SECOND FLOOR PLUMBING PLAN

ADDENDUM 3 REVISED 08/20/07ab
 REVISED 03/07/07ab
 REVISED 2/19/07
 REVISED 1/24/07

2ND FLOOR PLUMBING PLAN
 ST. TAMMANY PARISH ADMIN. COMPLEX
 520 OLD SPANISH TRAIL
 SLIDELL, LOUISIANA

RENOVATE OFFICE BUILDING
DAMMON ENGINEERING, INC.
 1095 FLORIDA AVENUE 985-649-5832 SLIDELL, LA. 70458
 DAMMONENGINEERING.COM

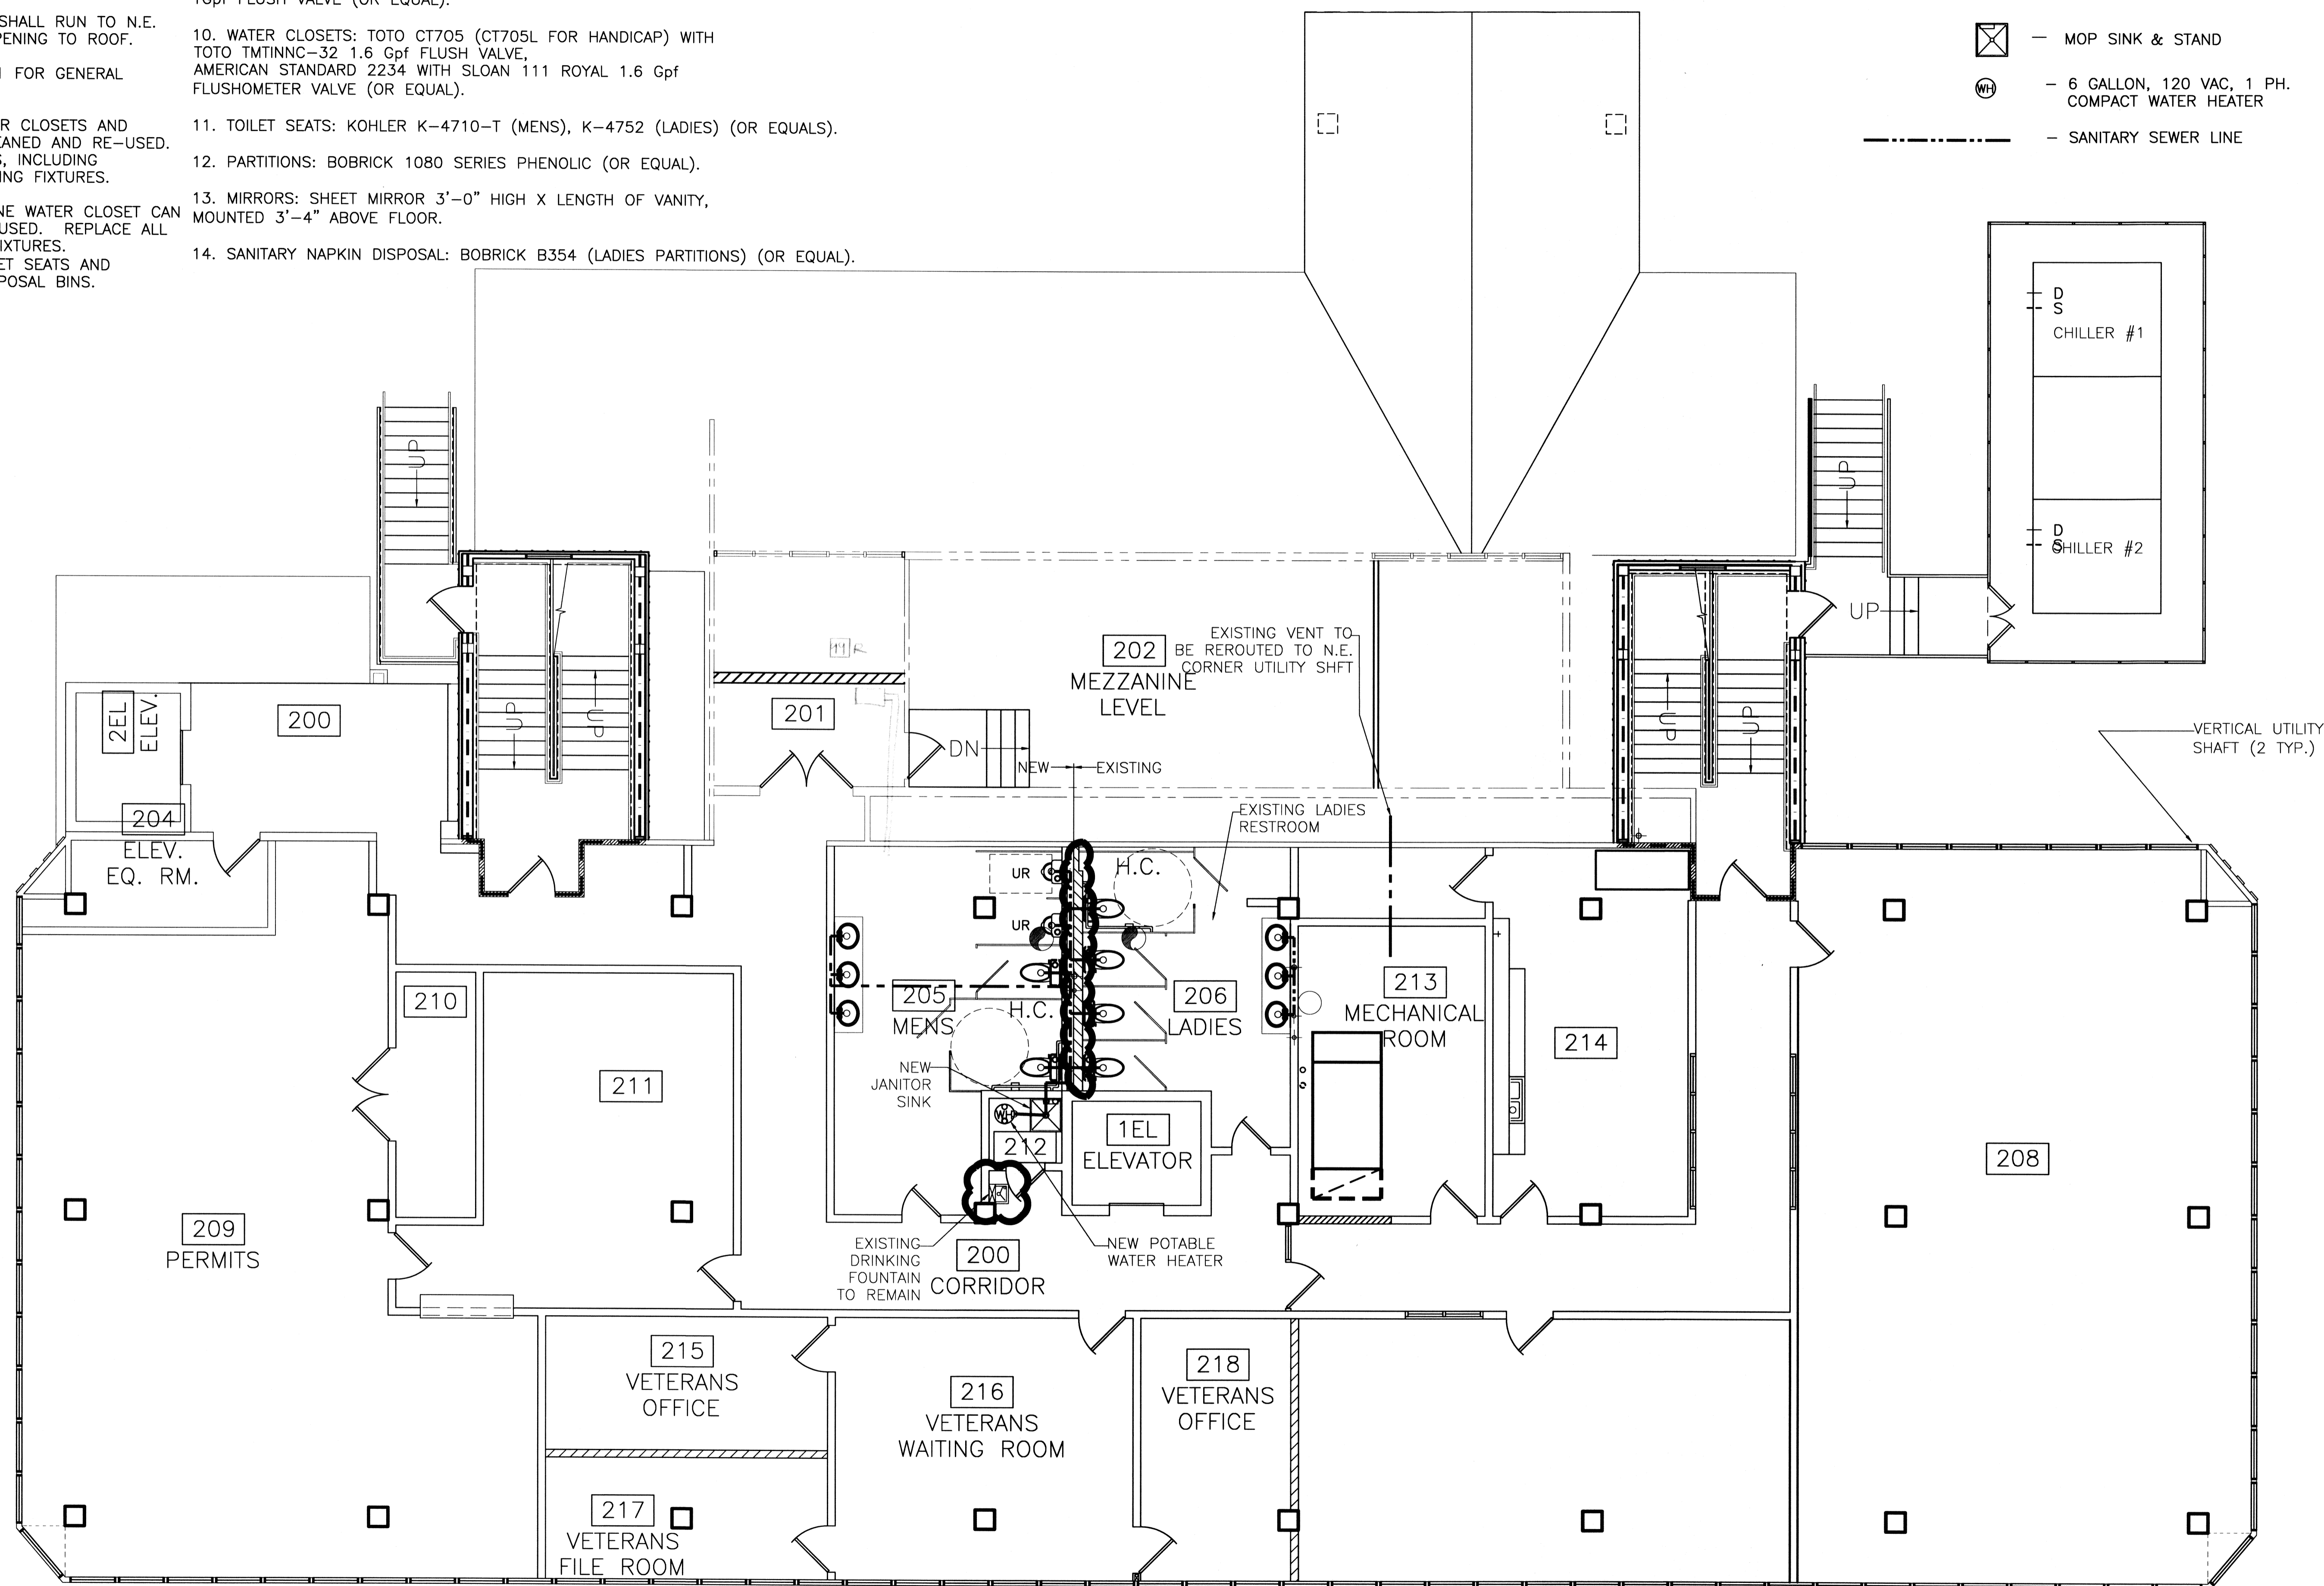
= ADDENDUM 3 CHANGE
